GEORGETOWN-SCOTT COUNTY PLANNING COMMISSION

**AGENDA
MAY 12, 2022
6:00 p.m.**

BLUEGRASS CAMPGROUND PHASE 1 FINAL DEVELOPMENT PLAN

Staff Report to the Georgetown-Scott County Planning Commission MAY 12, 2022

B SITE LAYOUT PLAN
1" = 40'

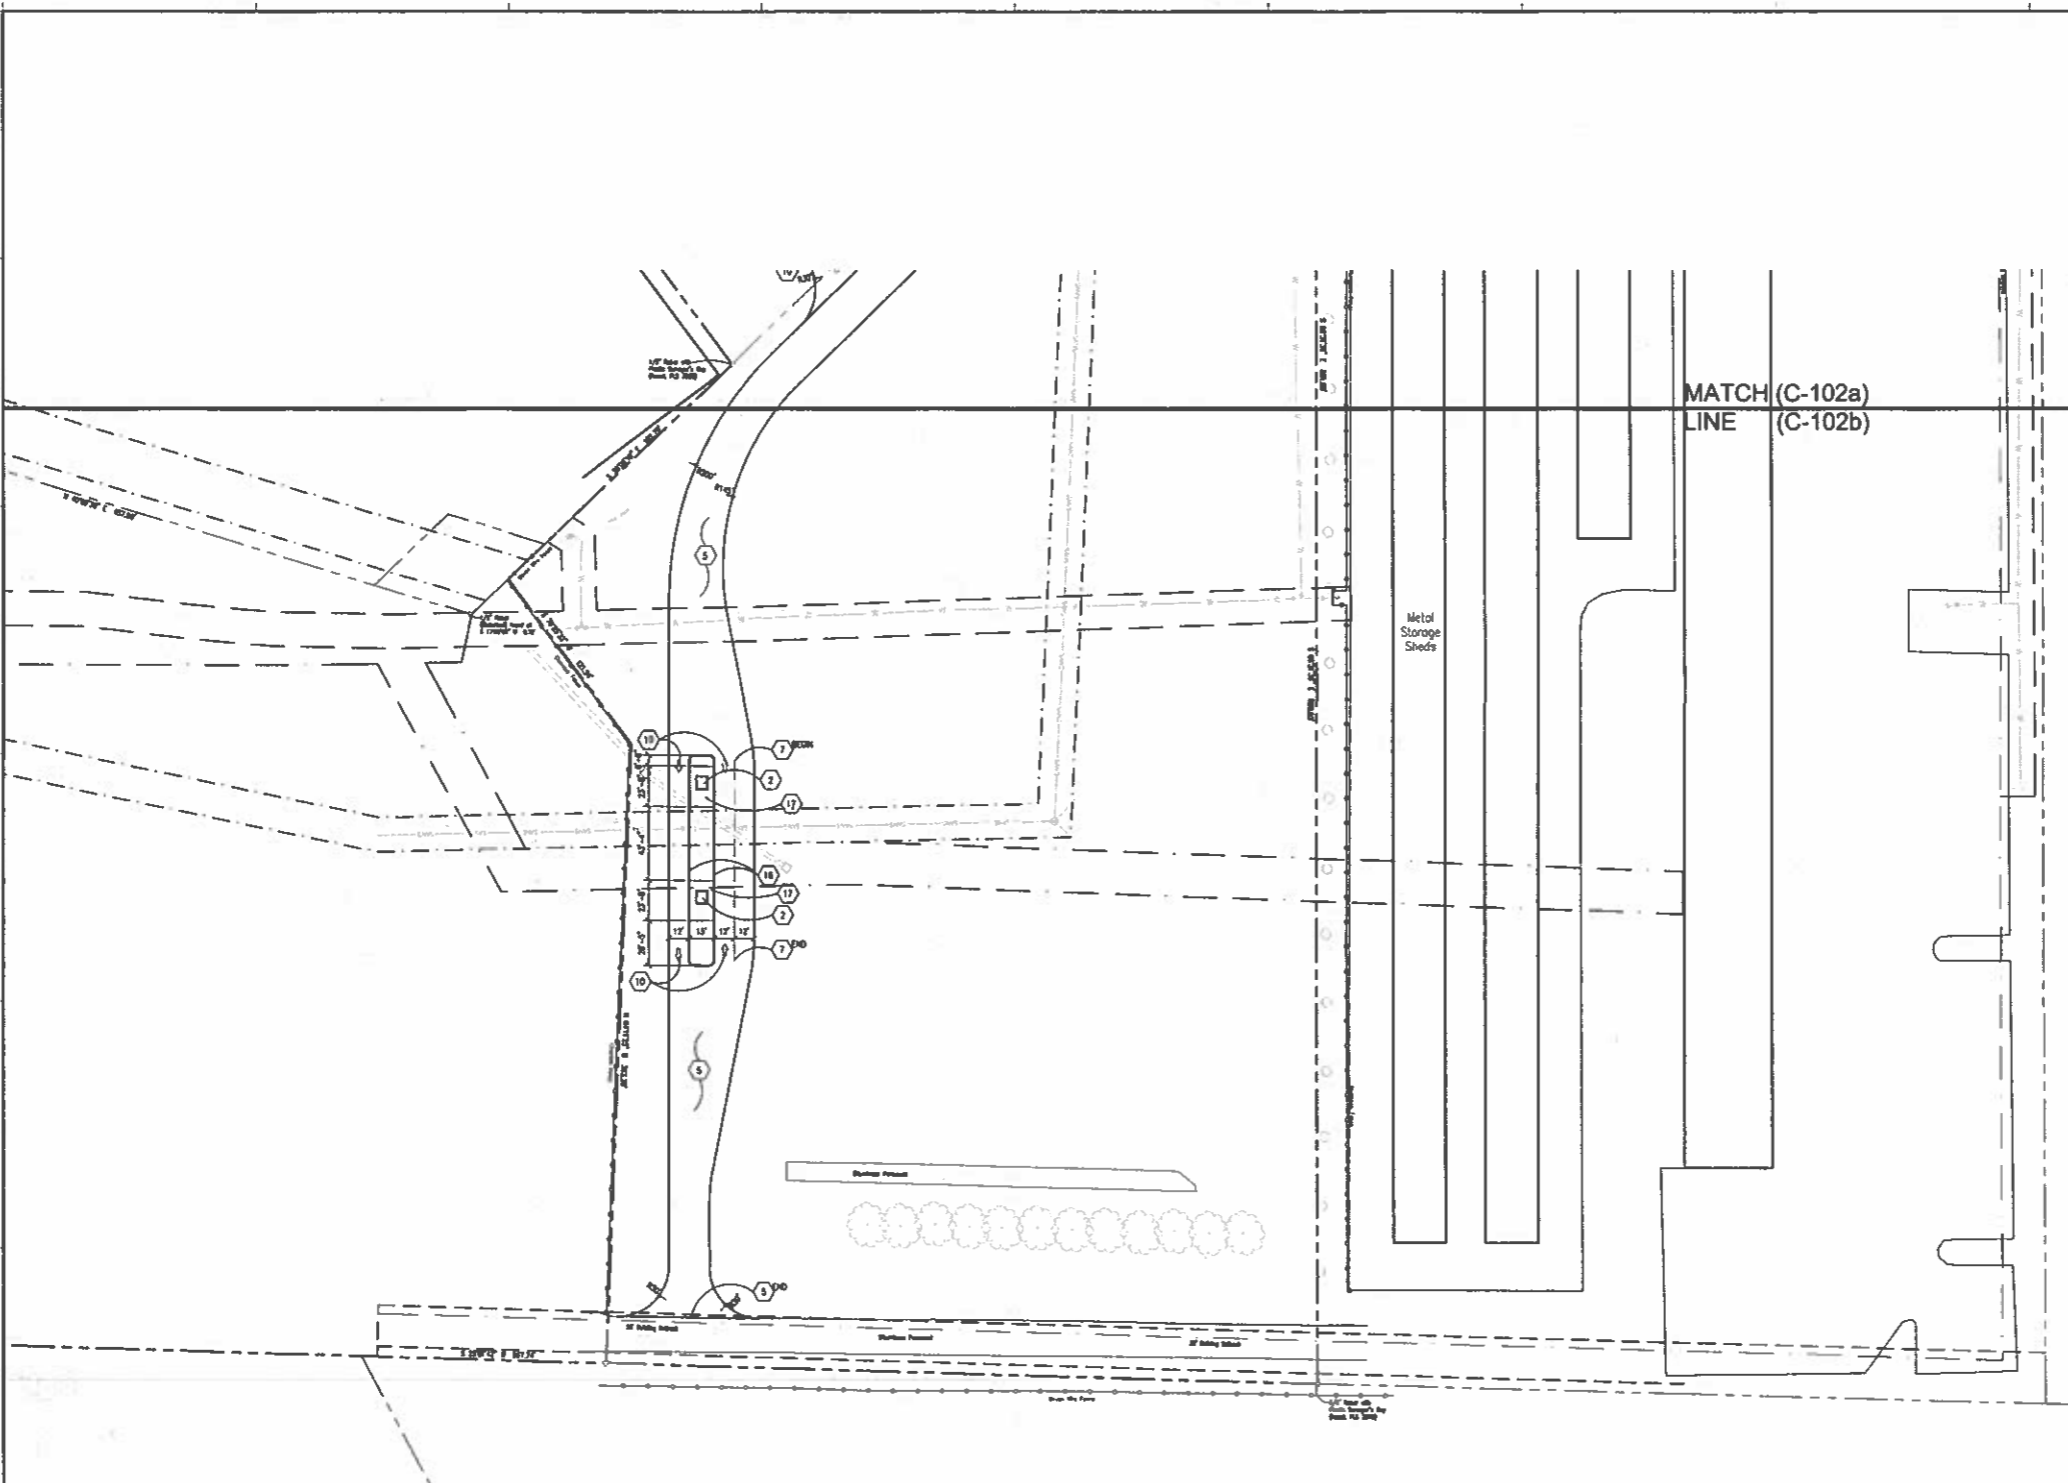
The adjustment to the main entrance and exit for the proposed development is the most substantive change. Previously, the development proposed guests would enter from and exit onto Connector Road (KY 2906) with a secondary exit onto Paris Pike (US 460). The Final Development Plan before the Planning Commission proposes to have vehicles enter the site from Paris Pike and exit onto Connector Road. Since this would impact the traffic flow in this area and increase the impacts on the adjoining residential development, staff has brought the application back to the Planning Commission for review.

The Planning Commission's concerns with the traffic generated by this site largely surround the types of vehicles that would most frequently visit the site, and how they can safely get into and out of the development. These larger, less agile vehicles typically need larger gaps in traffic to make turns, and thus have the potential to create delays in traffic if adequate turn lanes are not created to assist them in their turning movements. KYTC, in an email dated 4-1-2022, expressed some concern about the left turn lane length on US 460 for vehicles entering the development.

The eastern boundary, which adjoins the Rocky Creek neighborhood, will need a buffer area 15 feet wide populated with trees and other items as described in the ordinance. At the preliminary development plan approval in 2020, the Planning Commission granted a waiver to allow this buffer to be moved to the west side of the access drive. This was based upon the primary ingress and egress for the site being on Connector Road. Staff no longer supports this waiver because the primary entrance for the site will now be from US 460. There are established residential properties to the east of the Project Site that must be buffered from the commercial traffic generated by this development. The previously granted waiver to move the landscaping buffer should be rescinded due to the change in the traffic patterns for the development and to protect the public health, safety, and welfare. This will likely require the existing drive along the eastern property line to be moved further west away from the residential properties.

Staff recommends **approval** of the Development Plan amendments with the revised traffic patterns and the following waivers and conditions of approval:

7. The Applicant shall provide the additional tree canopy either on the Phase 2 site or the RV dealership site to bring the dealership's tree canopy coverage to 20% in accordance with the Conditions of Approval for FDP-2017-05.
8. The Final Development Plans for each phase will need to independently comply with all requirements of the *Zoning Ordinance* and *Subdivision and Development Regulations* including the *Landscape and Land Use Buffers Ordinance*.
9. The required landscaping buffers along the residentially zoned properties shall be installed with the first phase of development.
10. The Applicant shall comply with all requirements of the Kentucky Cabinet for Health and Family Services regarding the approval and operation of a recreational vehicle community.
